**CITY OF KELOWNA  
MEMORANDUM**

**DATE:** October 23, 2007  
**File No:** Z07-0029  
**TO:** City Manager  
**FROM:** Planning & Development Services Department  
**SUBJECT:**

**APPLICATION NO.** Z07-0029      **APPLICANT:** Kevin & Cynthia Patterson  
**AT:** 530 Ziprick Road      **OWNERS:** Kevin Patterson  
Cynthia Patterson

**PURPOSE:** TO REZONE THE SUBJECT PROPERTY FROM THE RU1 - LARGE LOT HOUSING ZONE TO THE RU6 - TWO DWELLING HOUSING ZONE IN ORDER TO ALLOW FOR THE CONSTRUCTION OF A SECOND SINGLE-FAMILY DWELLING.

# ZIPRICK ROAD SITE PLAN

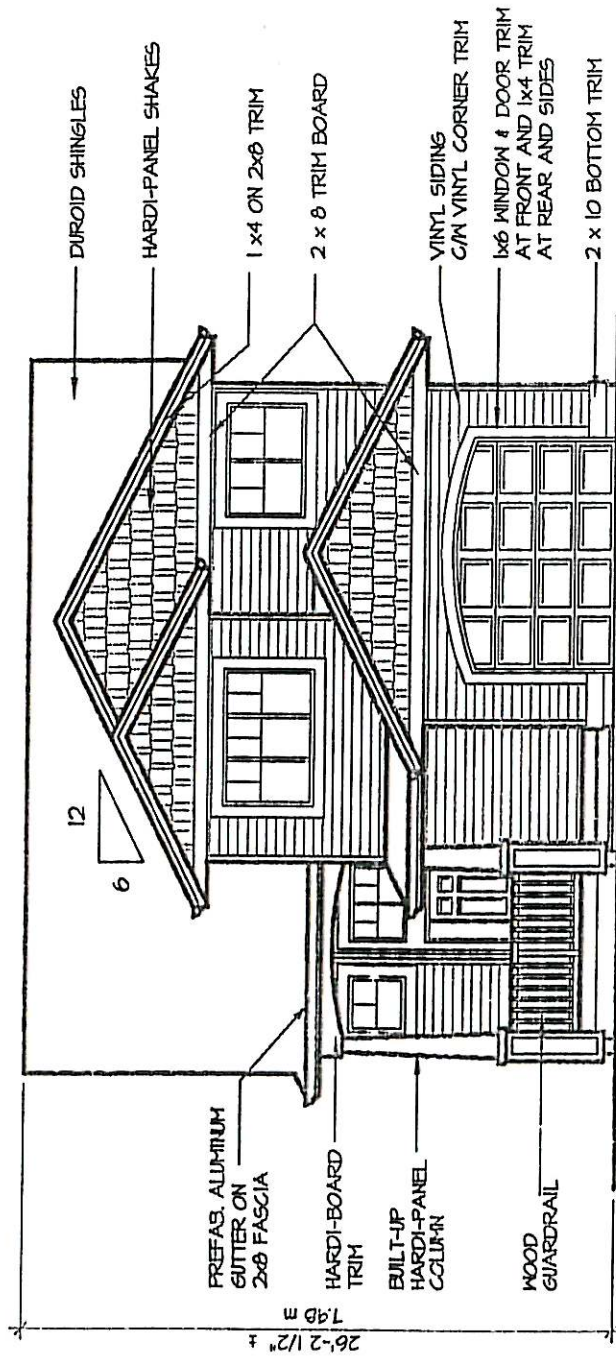
Provide spatial separation calculations and code analysis for north and south elevations of proposed dwelling.
